# Response to Technical Review Comments

## Clear River Energy Center and Burrillville Interconnection Project

Application No. 17-0079

**Re: Clear River Energy Center, LLC  
Burrillville RI  
Application No. 17-0079**

SHEET  
01C400  
7 OF 18

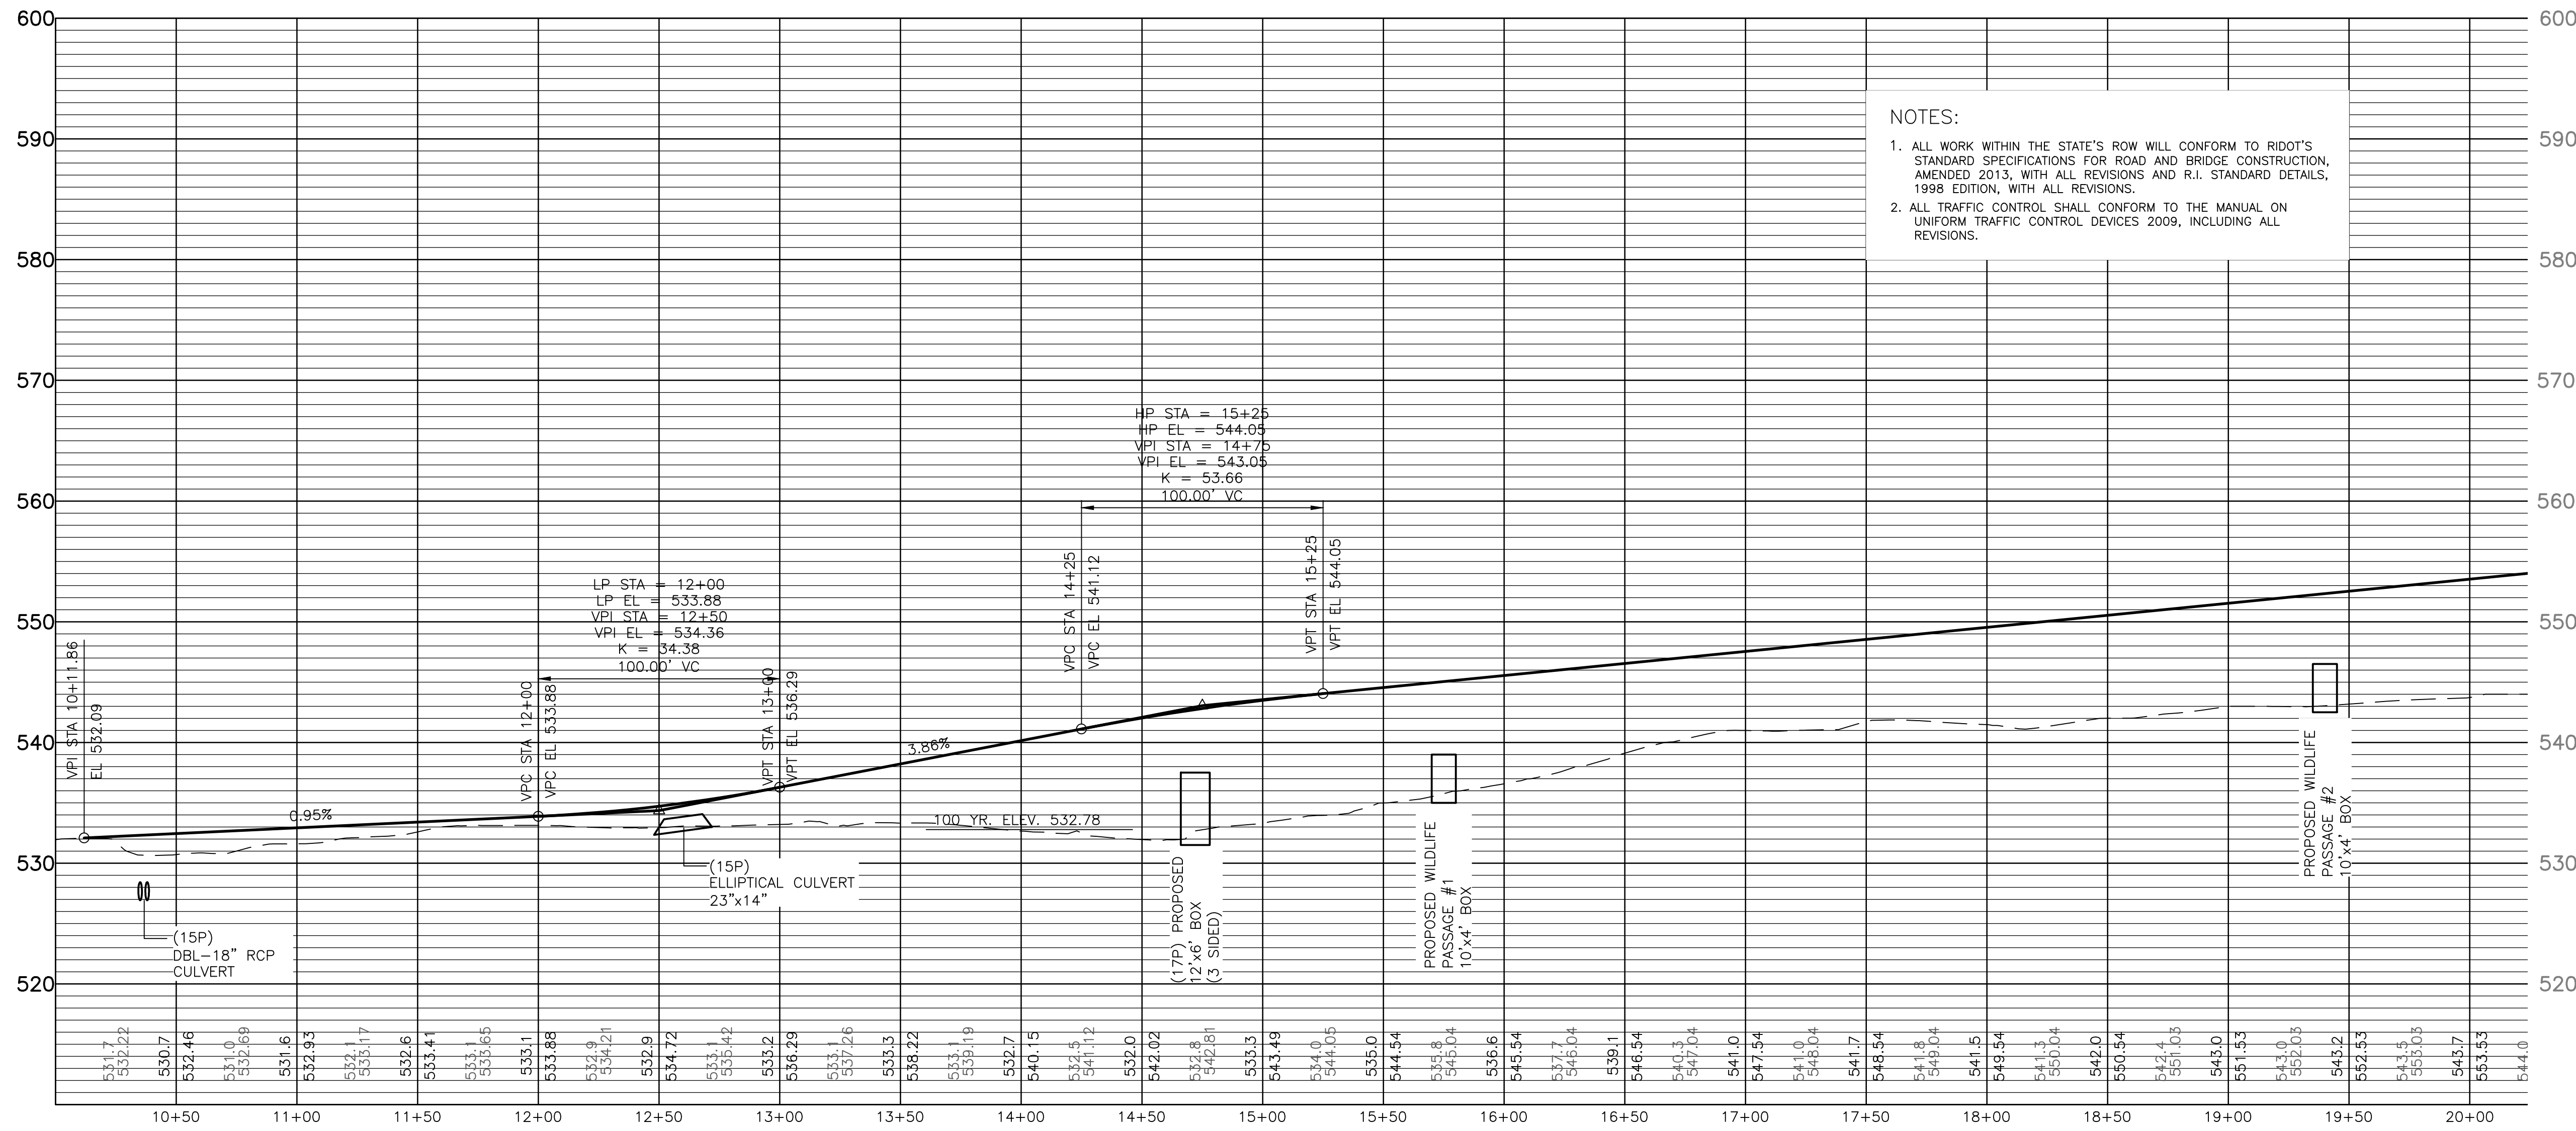
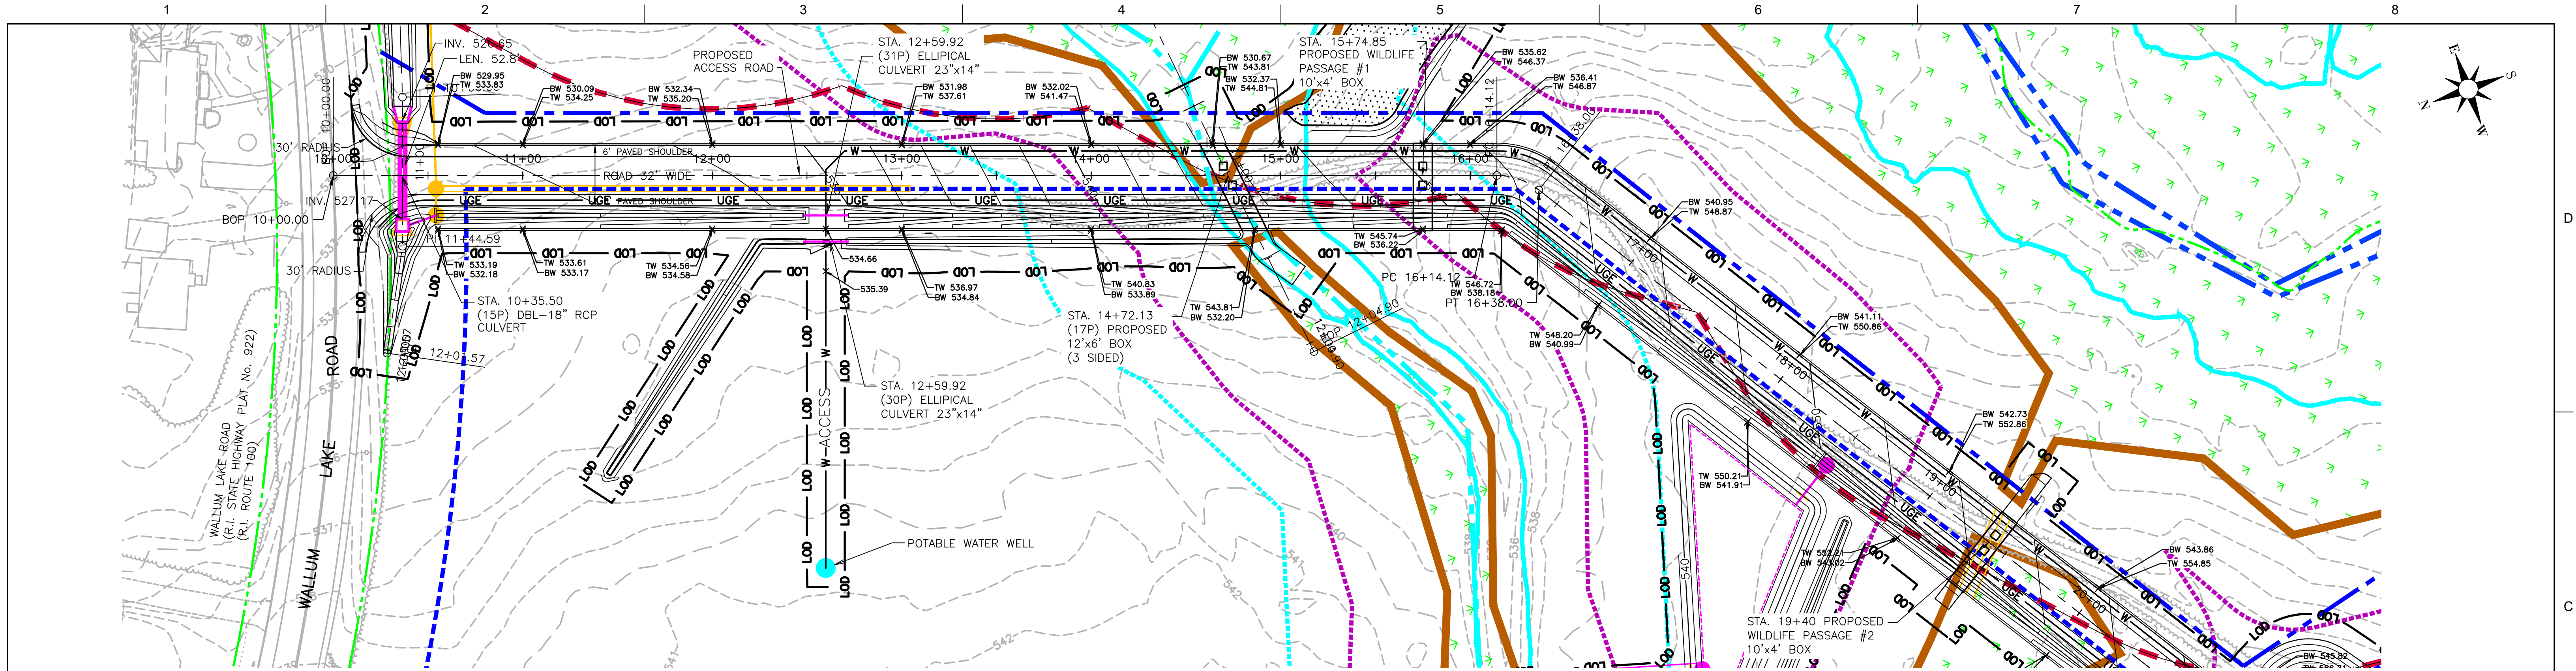
**Response:** The break in the LOD line and an explanatory note have been added to the Proposed Grading Plan (Sheet 6 of 18) and on the Proposed Drainage Plan (Sheet 7 of 18) (see Exhibit 1 Volume 1).

SHEET  
01C600  
8 OF 18

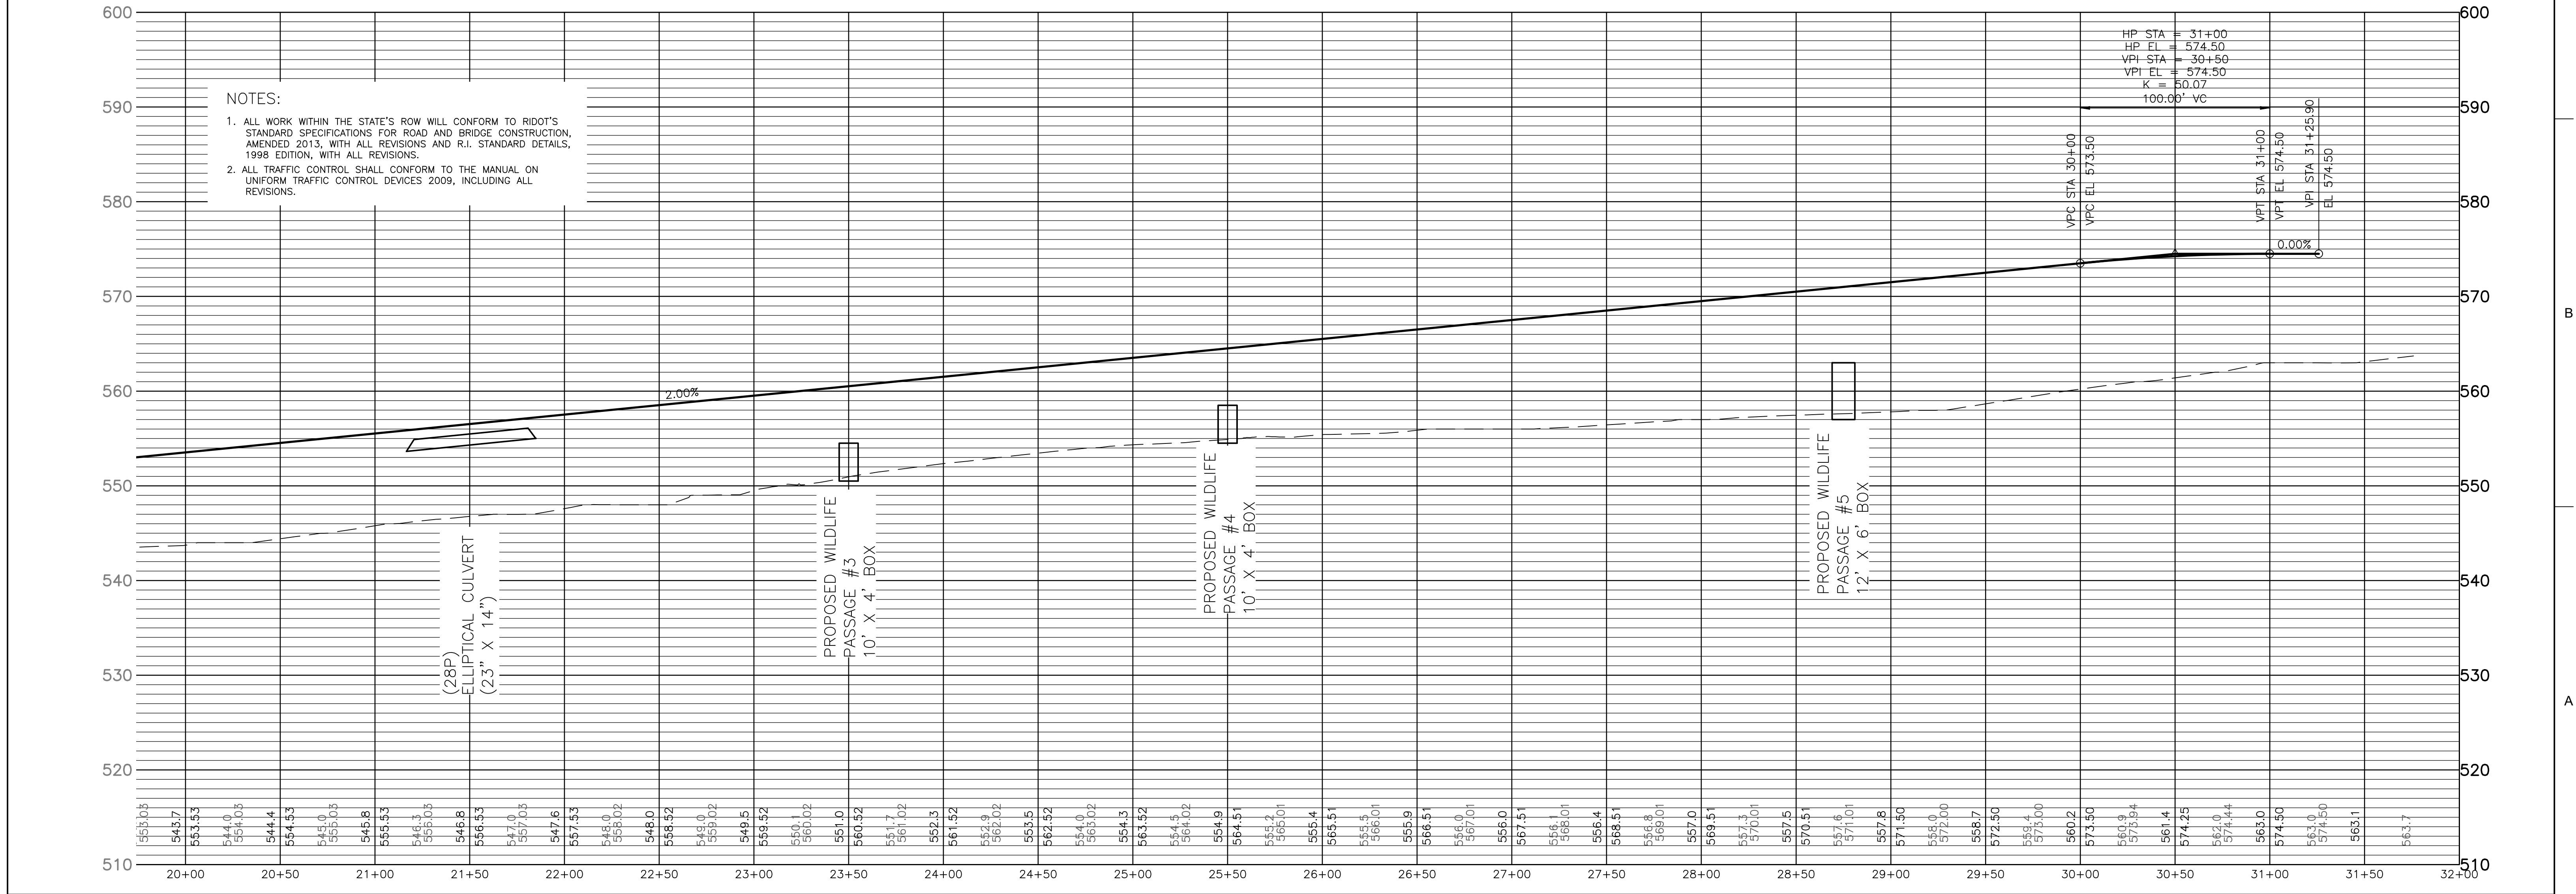
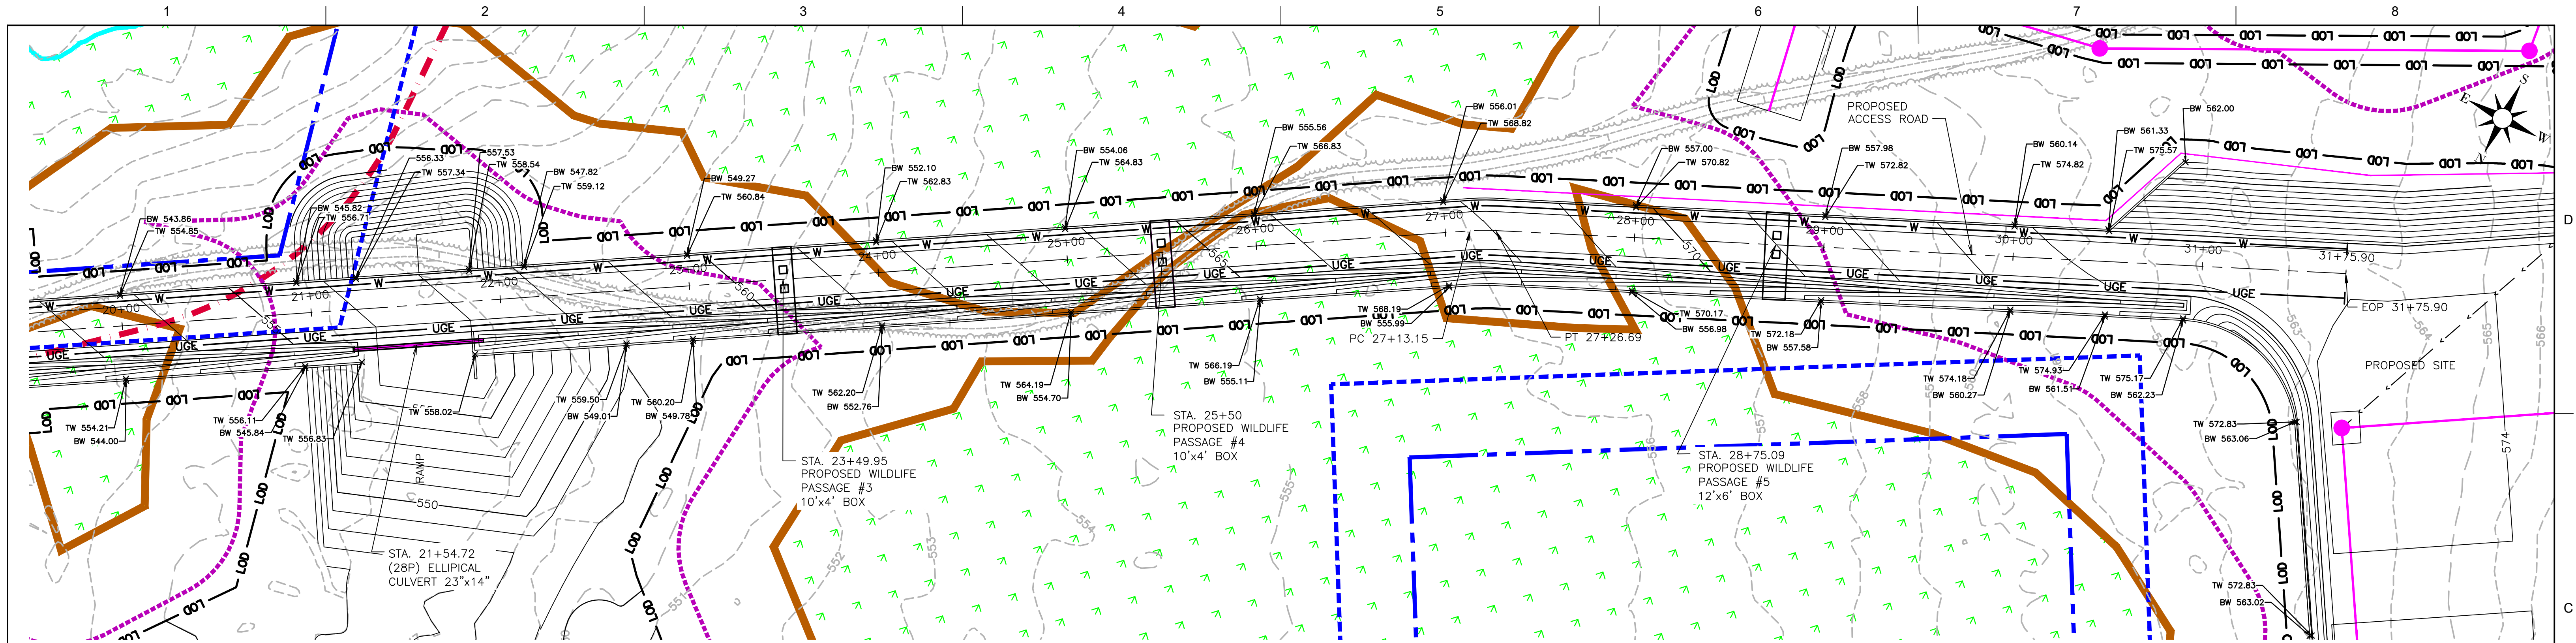
**Response:** The Roadway Plan and Profile sheets (Sheets 8 and 9 of 18) as well as the Utility sheet (Sheet 5 of 18) now show the proposed water and electric lines. Note that the electric line is labeled Under Ground Electric (UGE) and the Water Line as "W". The distribution of these utilities within the footprint of the plant will be designed by the EPC contractor at a later date, along with the rest of the underground utilities.

0. The inlet and outlet elevation of the 18-inch pipe culvert are shown on the Roadway Plan and Profile, Sheet 8 of 18. These inverts are also shown in the cross section for Culvert 1 on Sheet 17 of 18 (see Exhibit 1 Volume I).
1. The details of the 3-inch by 18-inch vertical orifice are shown on Detail 3/01C803, Sheet 15 of 17 (see Exhibit 1 Volume I).
2. The dimensions of the inlet structure are shown on Detail 3/01C803, Sheet 15 of 17 (see Exhibit 1 Volume I).

**Response:** The plan area is shown on the Flood Plain Map 6 of 6 (Exhibit 8). The Flood Elevation is shown in the profile on sheet 8 of 18 (Exhibit 1 Volume I).
